Walk Ride Bath - Bath Walking Wheeling Cycling Links Response

Introduction

| RUH to River Avon towpath at Fieldings Road bridge..... | 16 |

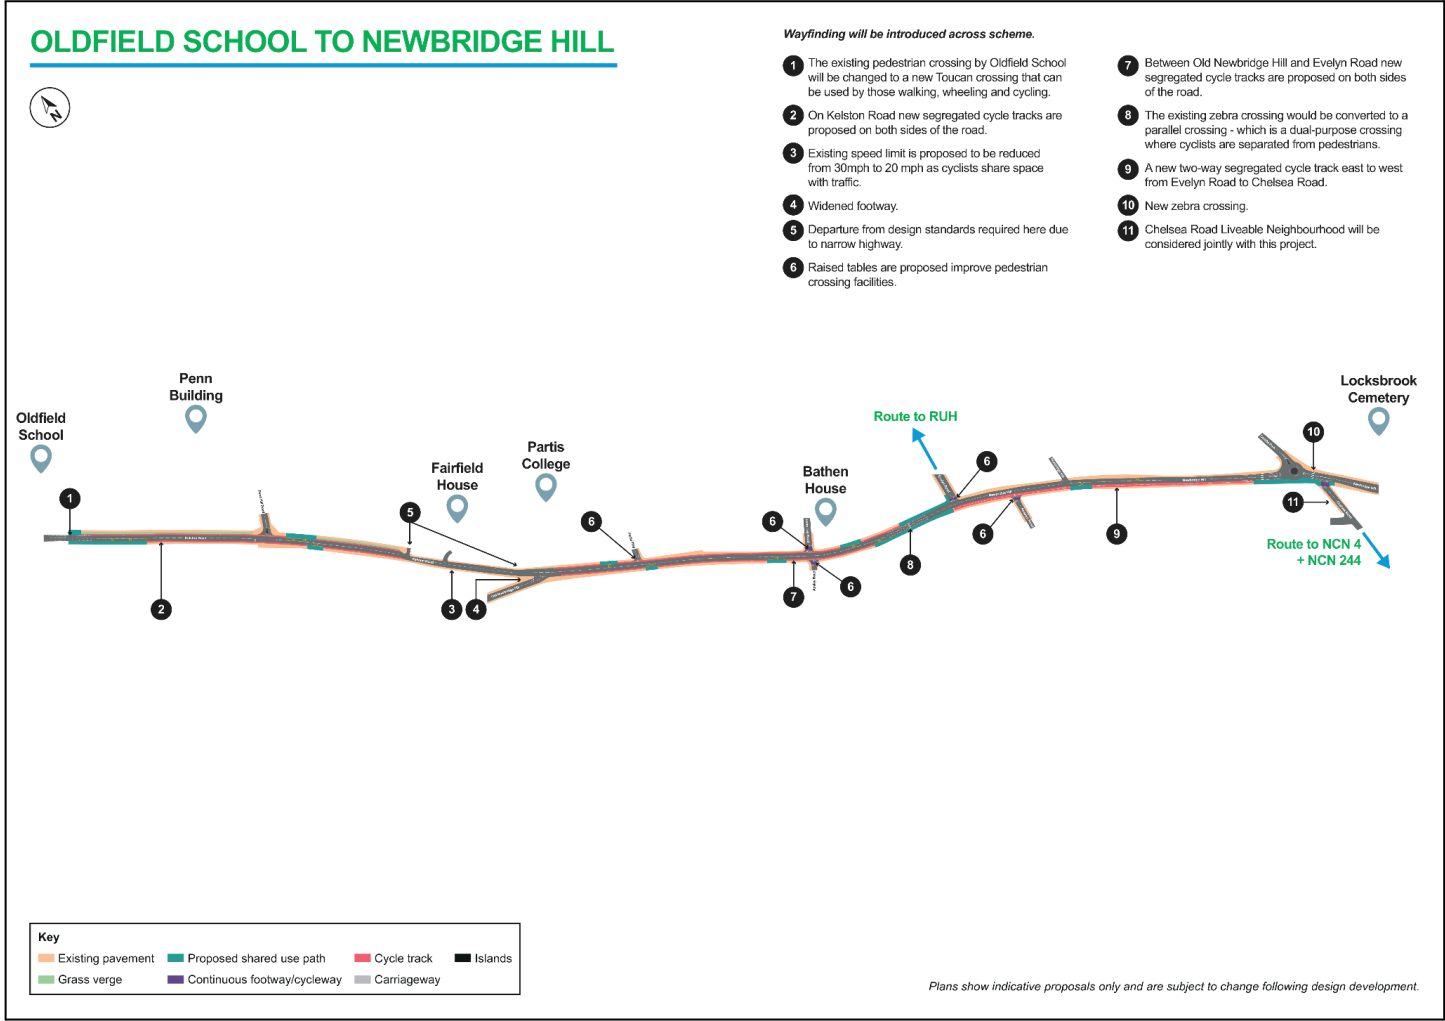
Given desire lines, the parallel (toucan) crossing should be aligned with the entrance to Evelyn Road to create a direct and safe route to the RUH. If this is not done cyclists will just cut over from the protected cycle lane into Evelyn Road. Given the poor state of Evelyn Road resurfacing should be prioritised as part of the Highways Maintenance programme of work.

However while we await the Bath to Bristol Strategic Corridor scheme consultation, we request that the pedestrian crossing at the south end of Chelsea Road is made more responsive (less than 10 seconds).

| Kelston Road..... | 18 |

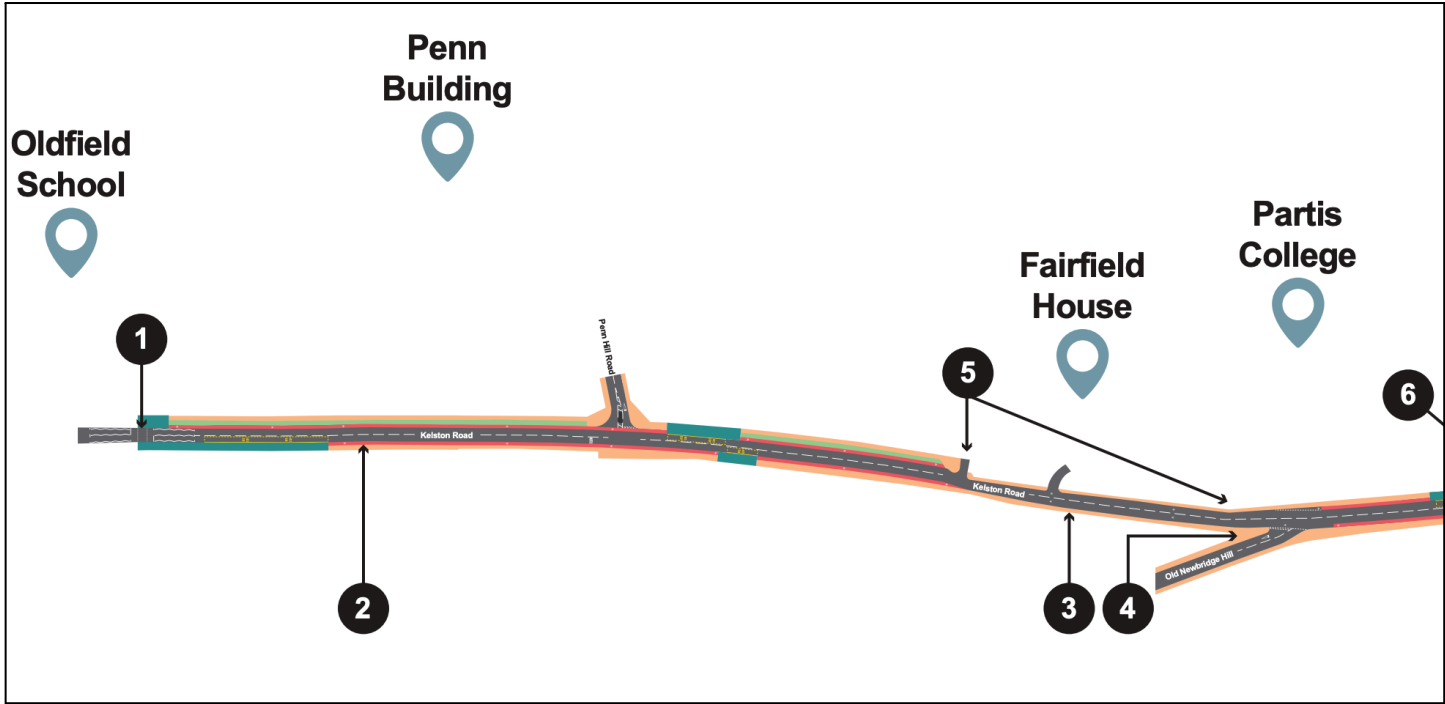
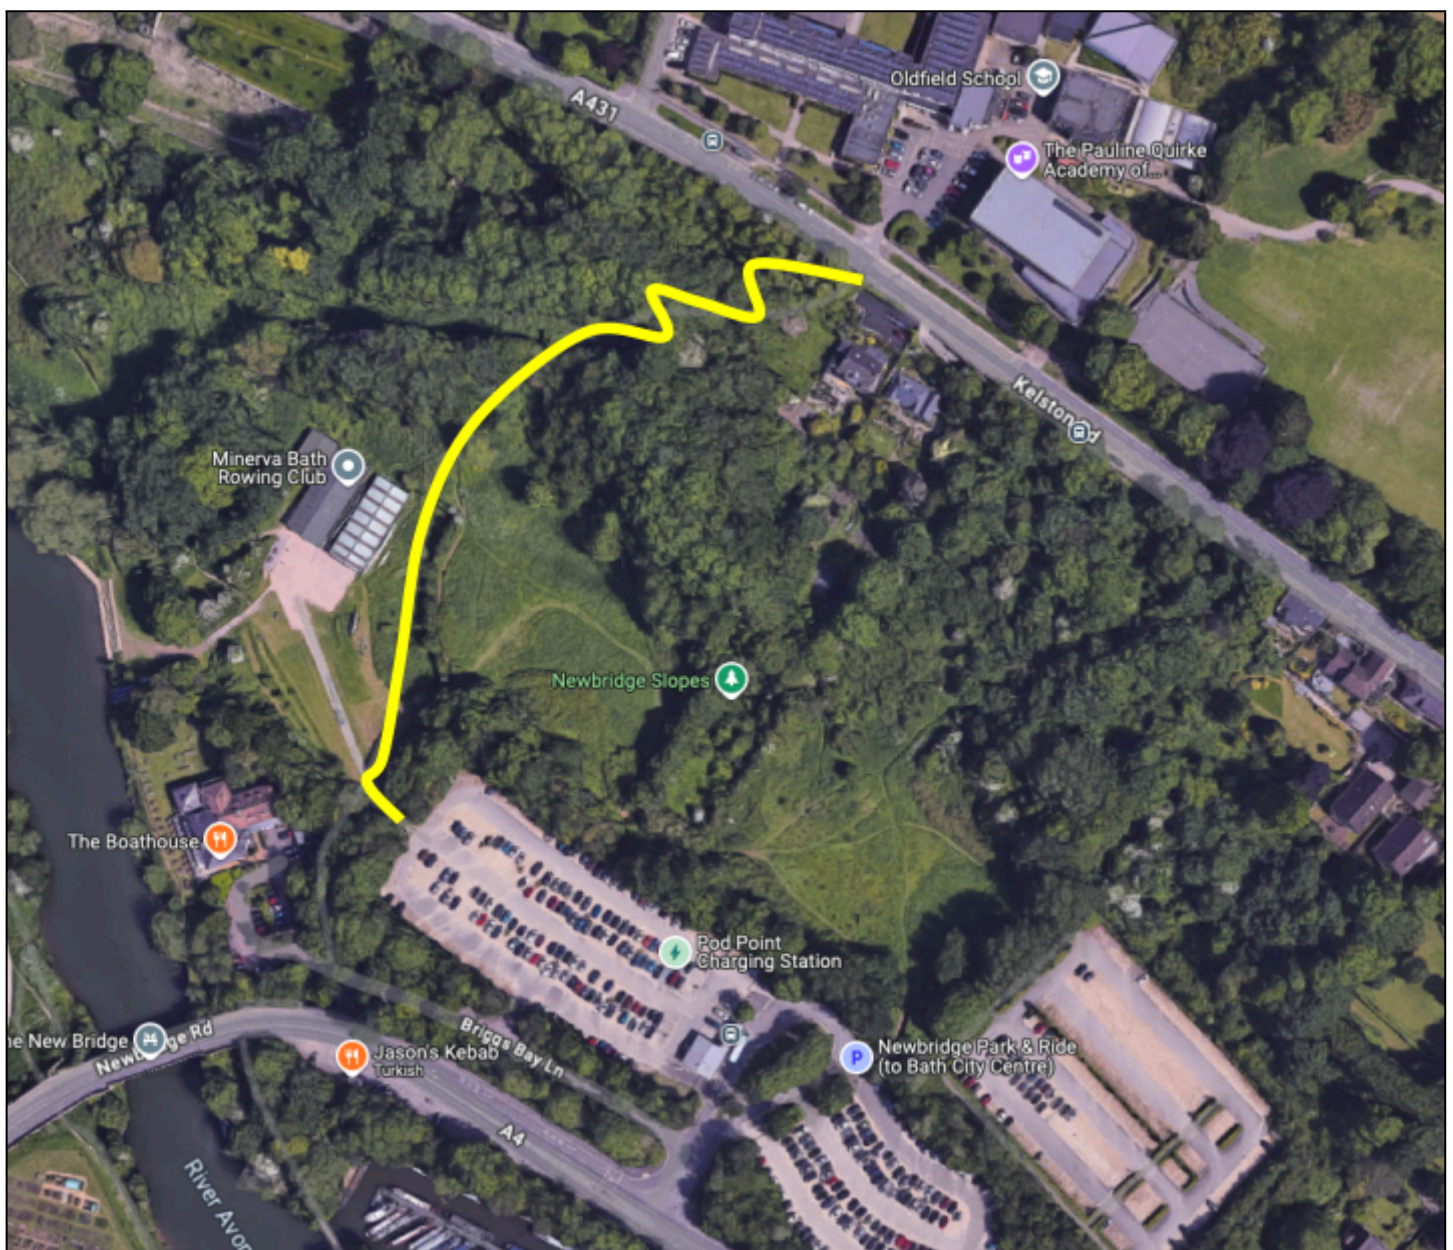
The scheme is generally good except for the Kelston Road/ Old Newbridge Hill junction. The reduction of speed does not bring this section into [LTN 1/20](#) compliance. This is a difficult section to design correctly and the council should use Active Travel England's [Design Assurance & Surgery services](#) to offer advice on this section.

It is suggested that there is high value in building a wheelchair friendly link between the Newbridge Park and Ride transport hub and Oldfield School for the benefit of all pupils and staff, and particularly those with disabilities, to replace the current unsurfaced and stepped PROW path, as shown in the image below. The Park and Ride provides further access towards the Bath-Bristol Railway.

| Newbridge Hill..... | 20 |

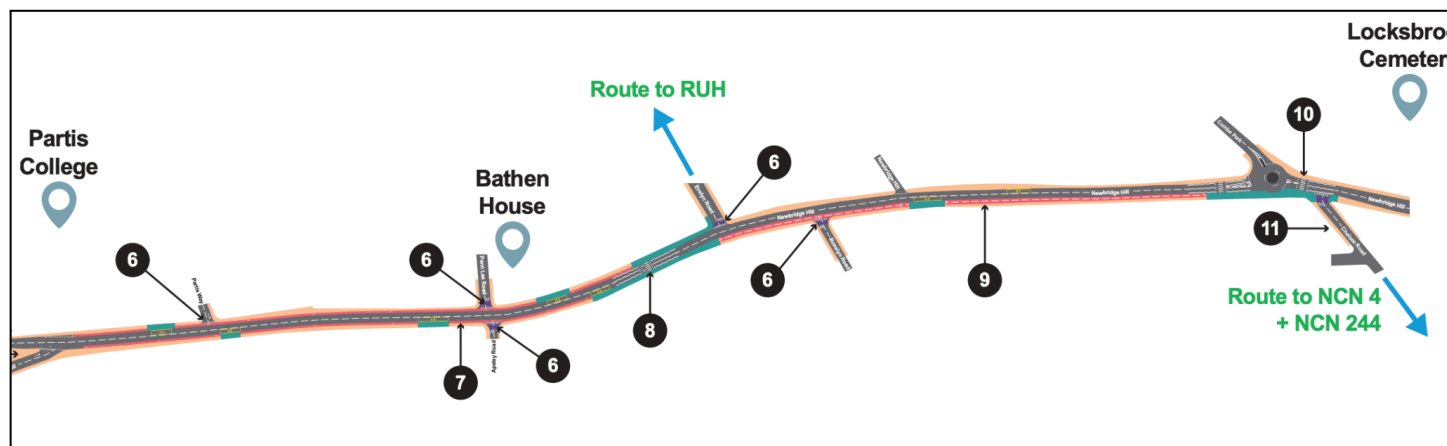
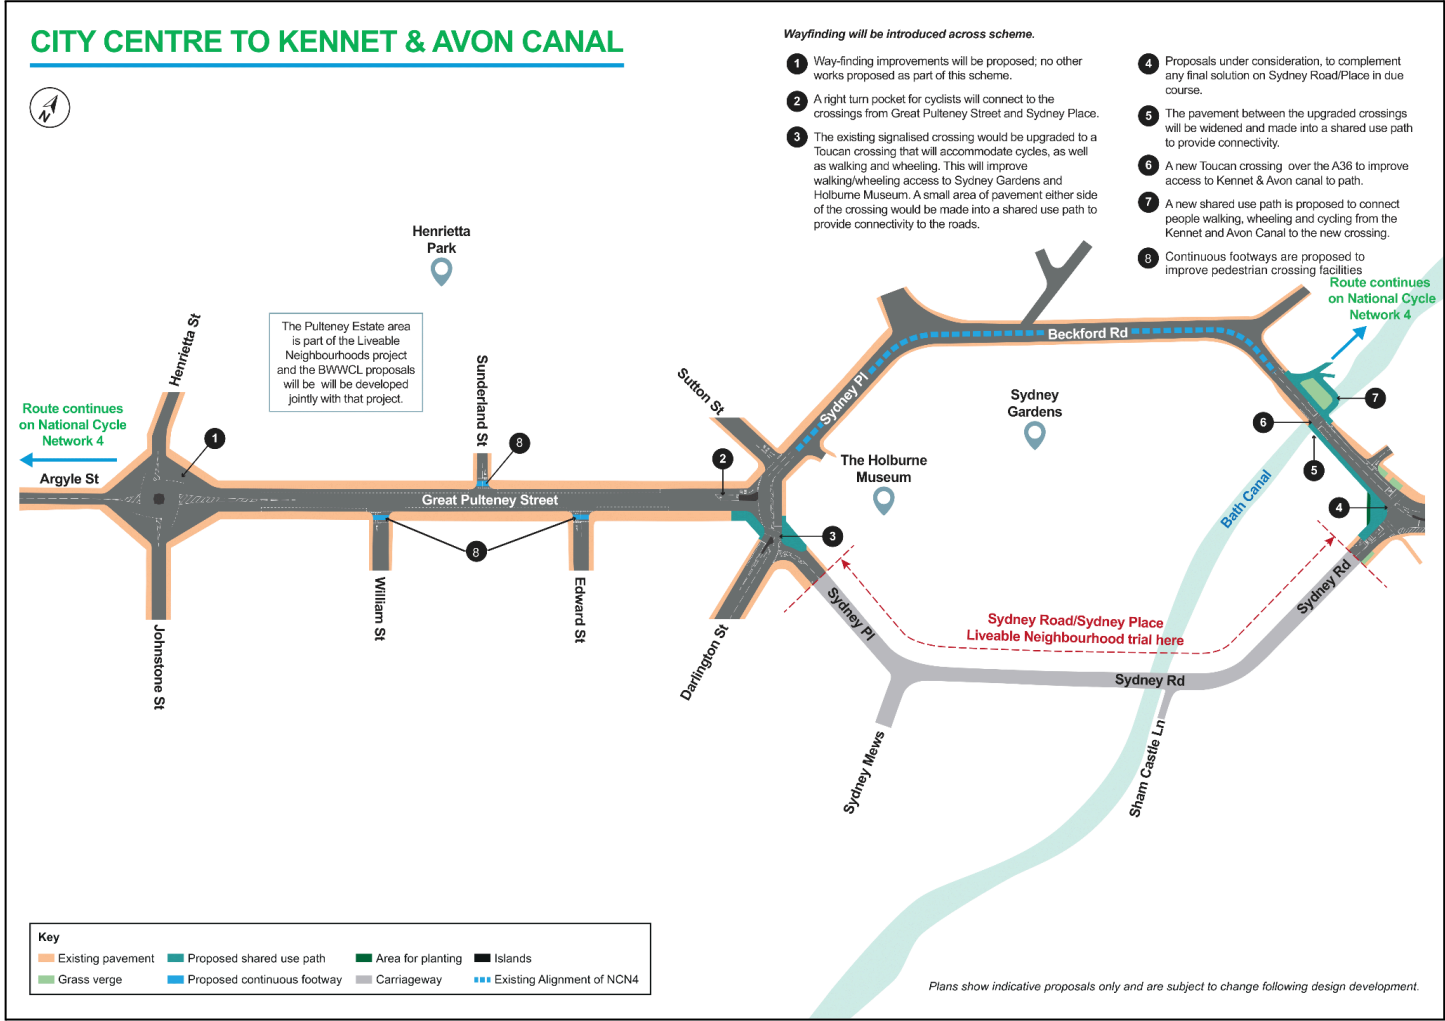
It is not clear why there is a switch between two way and one way cycle tracks at the Evelyn Road toucan which may cause unnecessary conflict. A consistent design approach fully along this section should be considered, either two way (3m+) or one way (2m + 2m), if achievable. A two way cycle track is understood to have advantages in terms of tidal flows and minimising width.

| Great Pulteney Street..... | 21 |

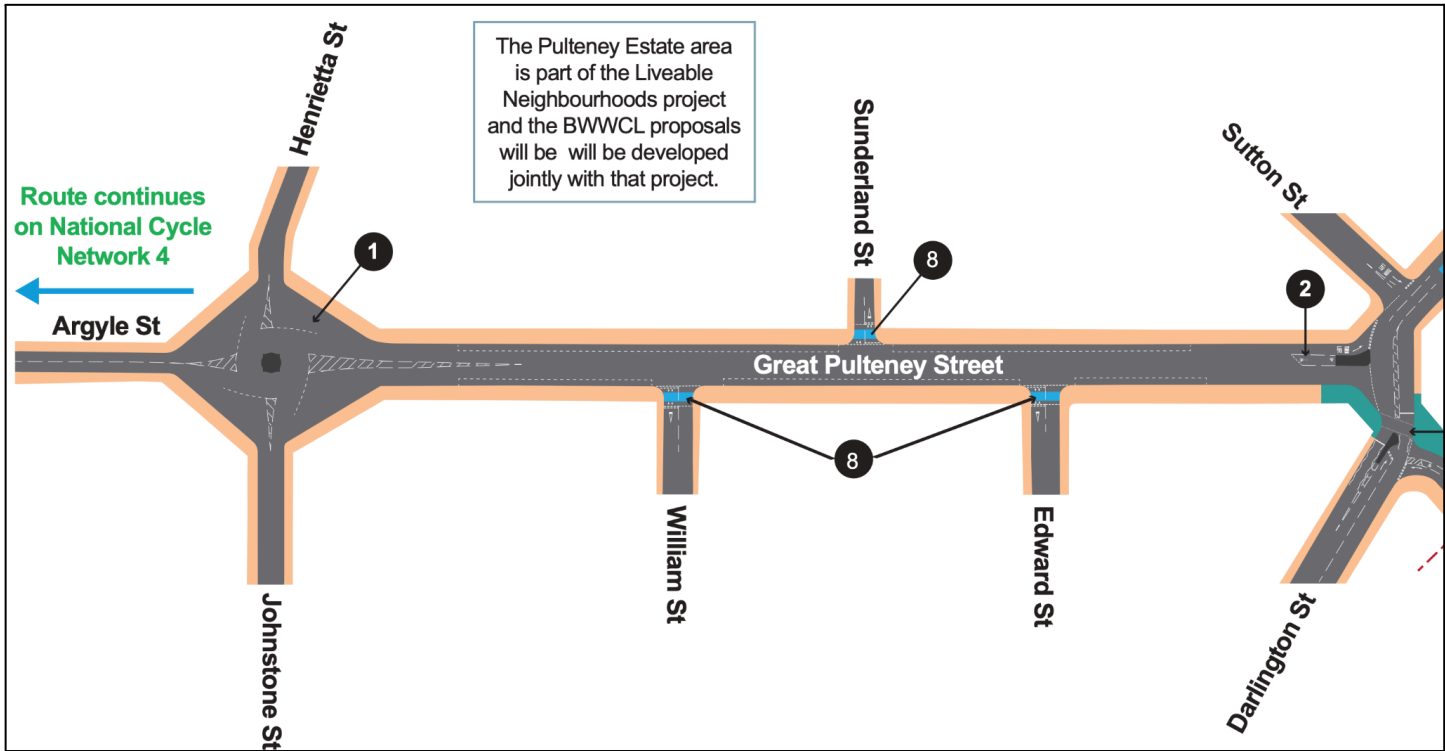
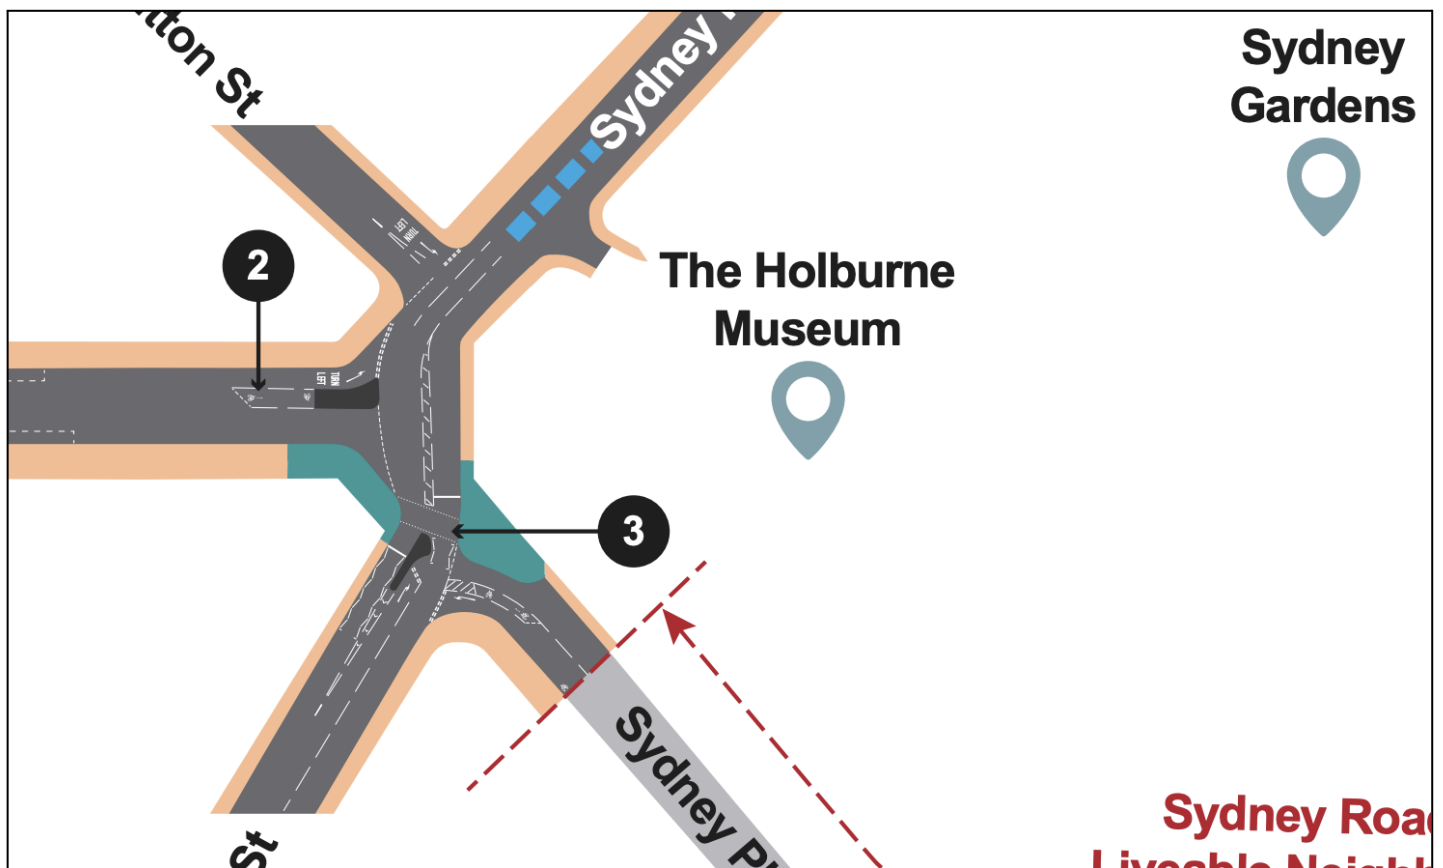
In terms of walking & wheeling, the continuous footways are very much welcome. We feel the scheme should go further with this approach and provide continuous footways across Johnstone St, Henrietta St, and Grove St (not shown) creating a good wheelchair accessible route into the city centre on both sides of Great Pulteney Street.

We recommend that a 24/7 bus gate is installed as this prevents confusion and aligns with the Pulteney Bridge bus gate restrictions.

| A36 Sydney Place upgraded crossing..... | 23 |

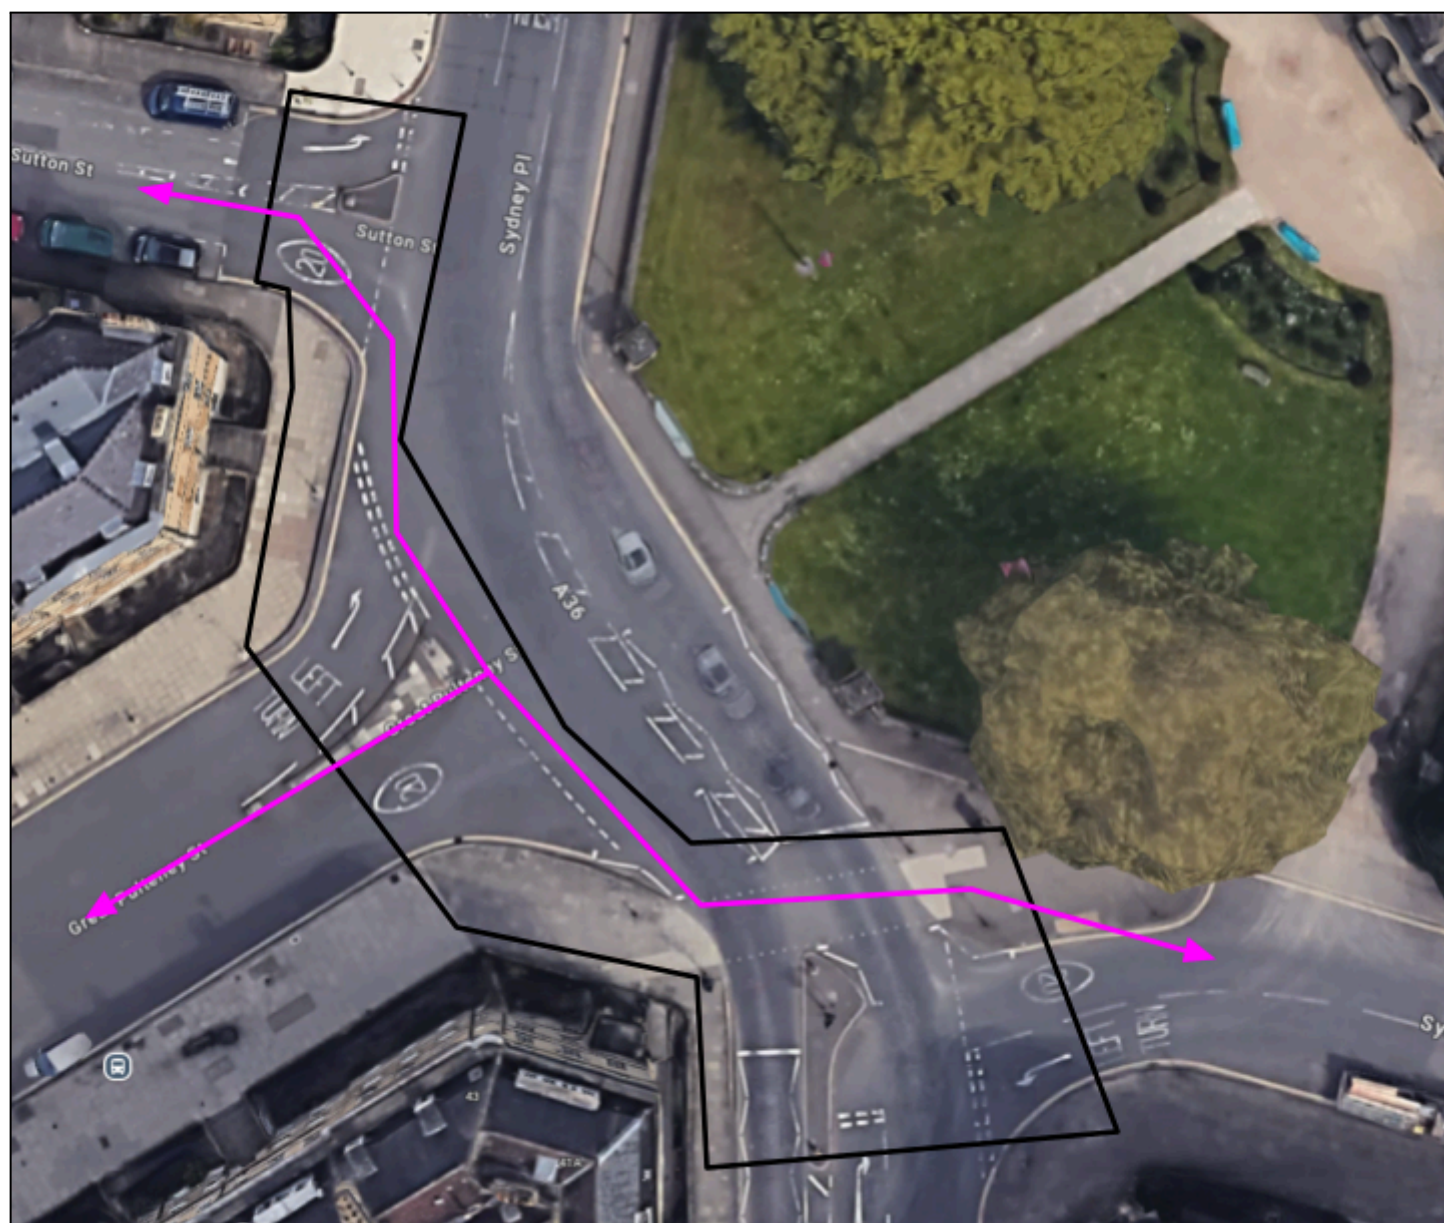
In terms of walking and wheeling the whole of the junction of Great Pulteney Street with the A36 should be treated as a continuous footway. The design of this space does not take into account the PELN proposal as set out in the LN FBC document.

- The A36 junction profile currently enables fast entry/exit for vehicles and should be tightened up to slow entry/exit speeds of motorised vehicles and facilitate safer pedestrian movements.
- The Toucan Crossing wait time should be minimised (under 10 seconds) with button position supporting cyclists using adapted cycles and cargo bikes.
- There is no consideration of how cyclists connect between the Sydney Place/Sydney Road LN and Sutton Street. The design of the junction should incorporate this important desire line:
